PLANNING COMMISSION MEETING

C. Jeff Hinds, Enbridge Gas District Regulator Station and High-Pressure Gas Feeder Line - Seeking Site Plan approval for upgrades to the District Regulator Station

located at 388 West 300 North, and high-pressure gas feeder line from the District Regulation Station to 4650 South 1200 West.

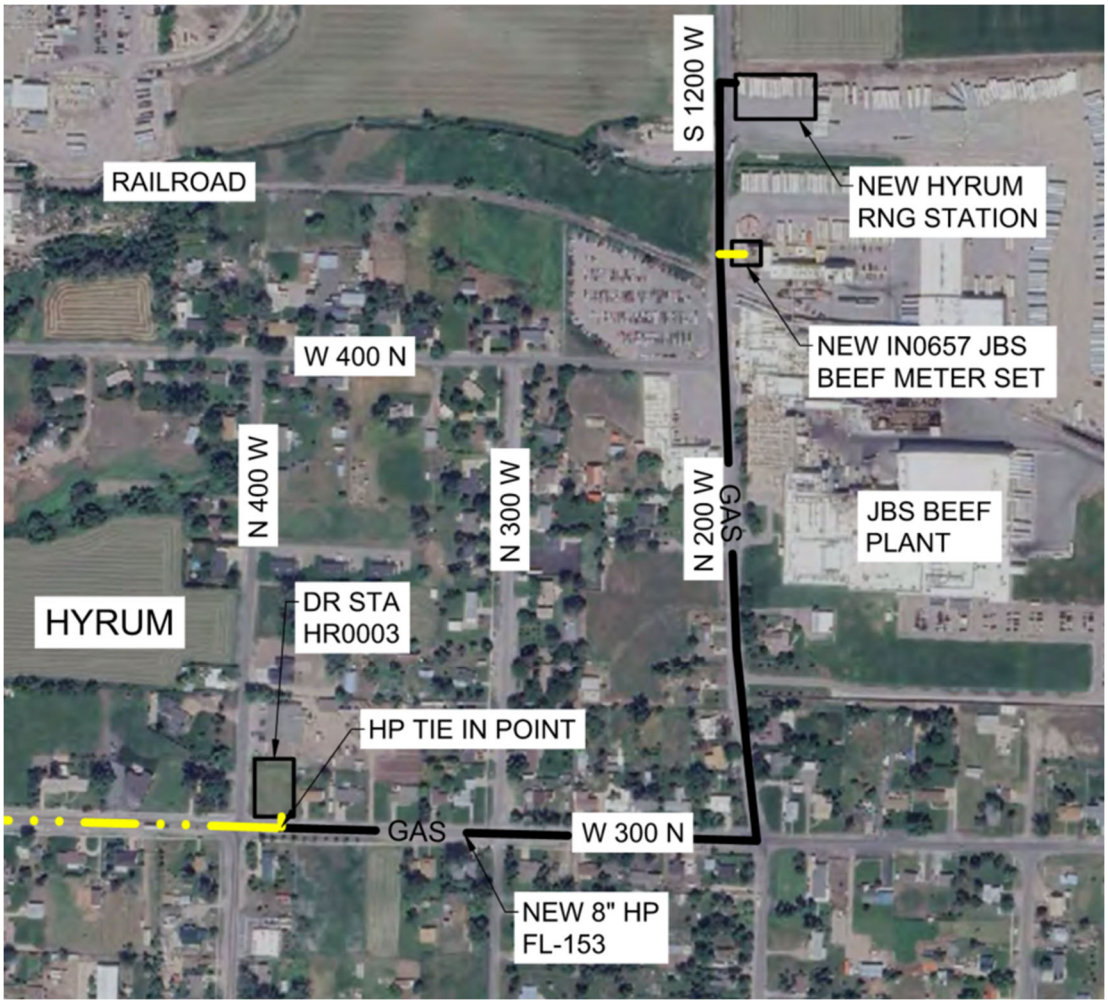
Currently, the existing Enbridge facility located at 388 North 400 West is non-compliant with Hyrum City Code and the following corrections need to be completed prior to the issuance of site plan approval:

1. Demonstrate noise levels at the direct regulator station are in compliance Hyrum City Code 9.50 Noise Disturbance.

2. The existing Fire Hydrant onsite will need to be raised in elevation.

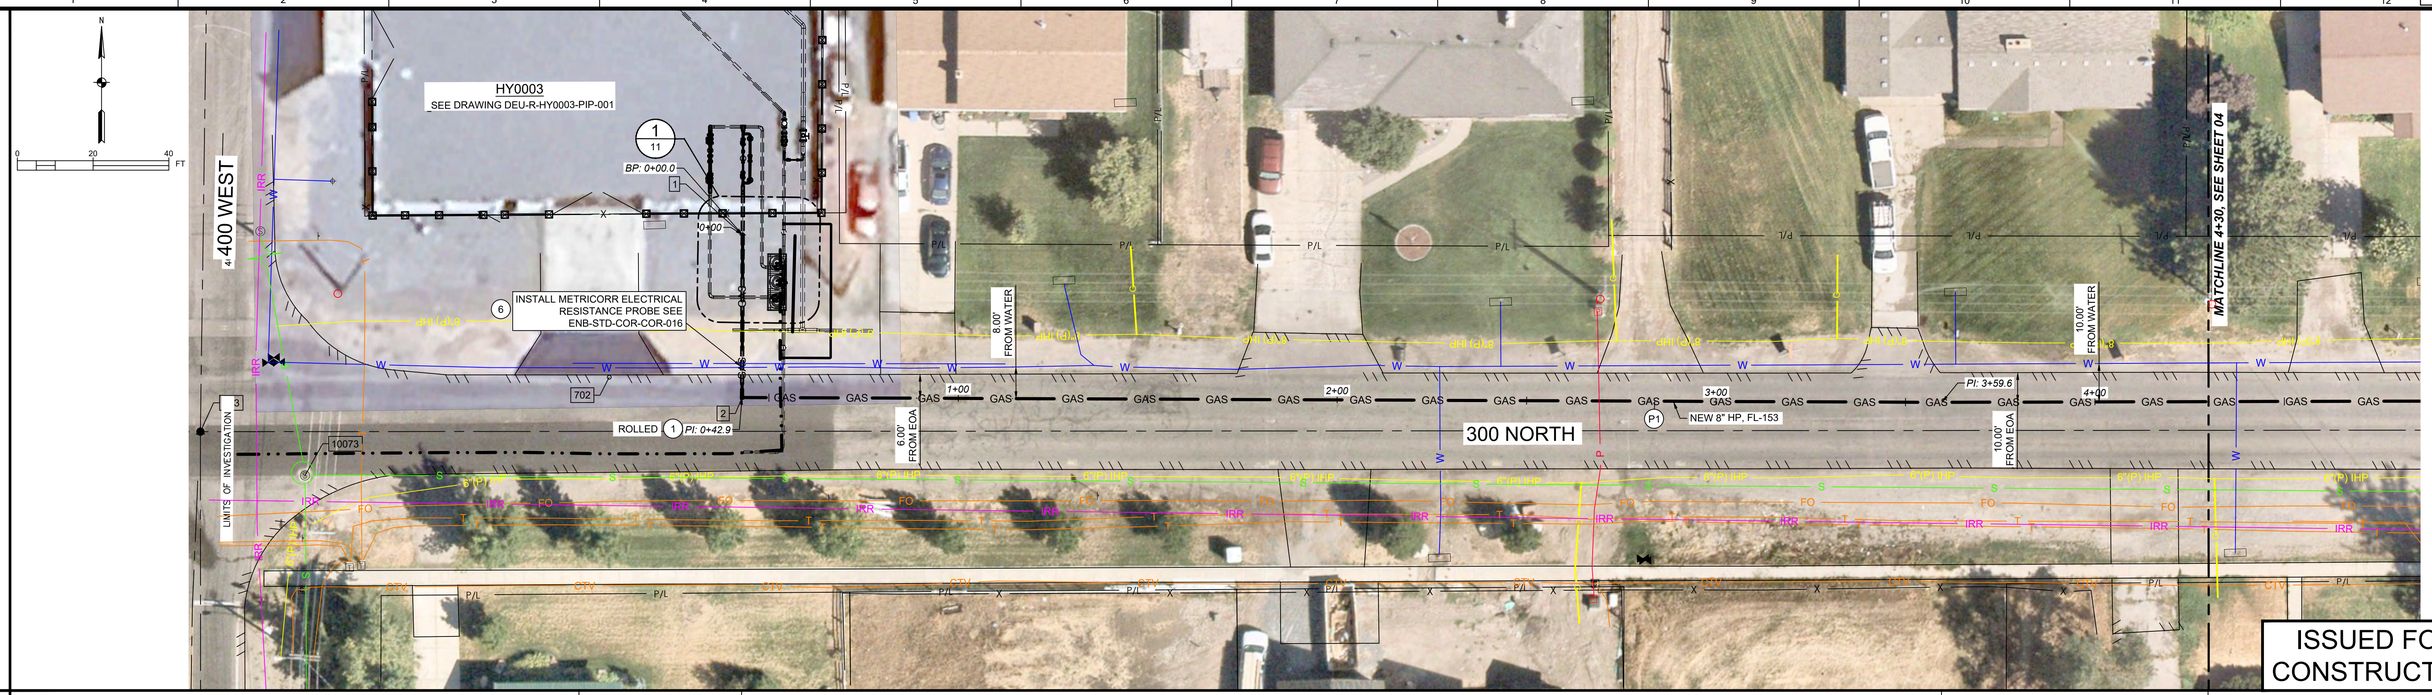
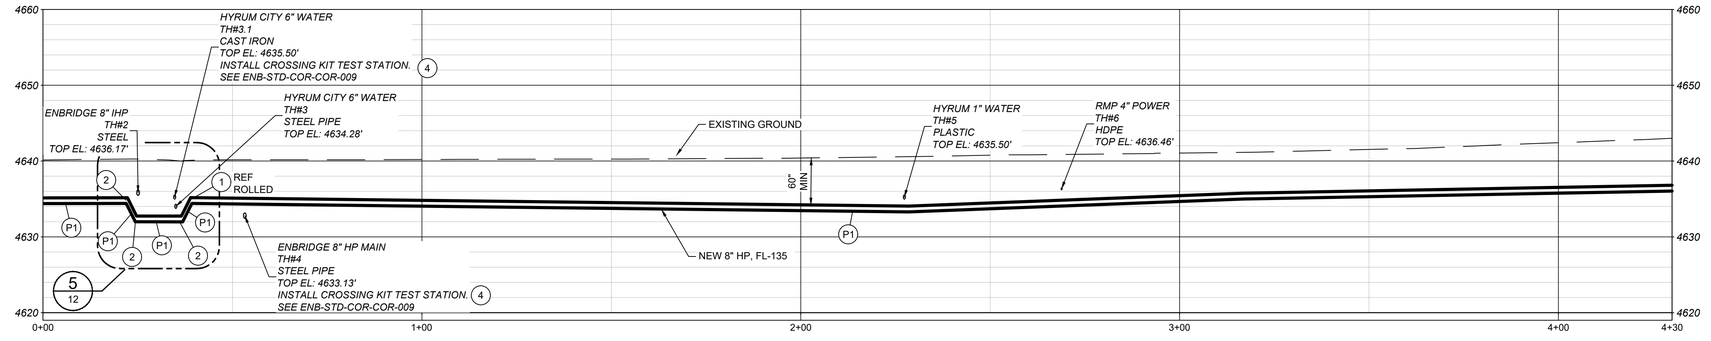
1. Be advised overhead power lines exist in the public right of way.
2. Work cautiously around underground power shown on Sheet 3 of 12 on the feeder line drawings.
